## 15B Failure Modes and Effects Analysis (FMEA)

The information in this appendix of the reference ABWR DCD, including all subsections, tables, and figures, is incorporated by reference with the following departures.

Figure 15B-1 Simplified CRD System Process Flow Diagram

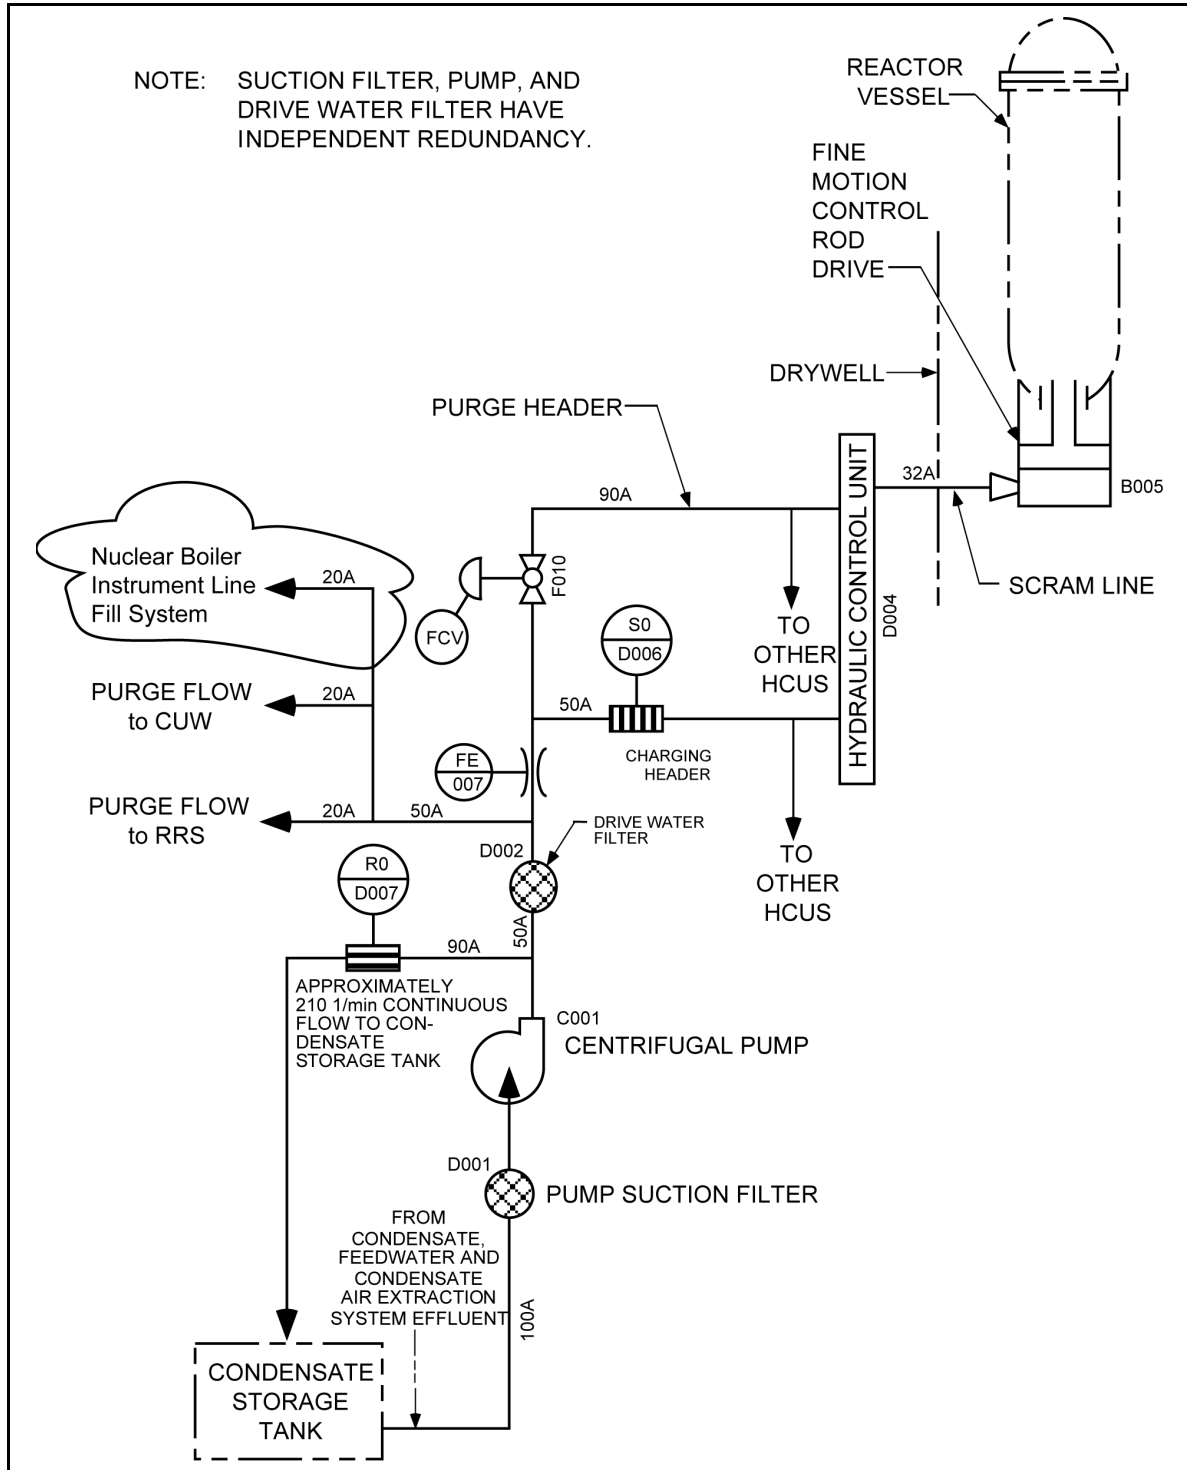
STD DEP 7.7-1 (Figure 15B-1)

STD DEP 7.7-1

*A simplified CRD System process flow diagram is shown in Figure 15B-1. CRD System water is taken from the condensate, feedwater and condensate air extraction system, or Condensate Storage Tank (CST) through a suction filter by a centrifugal pump and discharged through a drive water filter to the HCU's. (During shutdown the CST is the primary source.) Each of these components is independently redundant and only one of each is in operation at any one time. A portion of the pump discharge flow is diverted through a minimum flow bypass line to the CST. The pumped water is directed to the HCU to provide hydraulic scram and to furnish purging to the drive. This system also provides purge water for the reactor internal pumps, nuclear boiler instrument lines, and the reactor water cleanup pumps.*
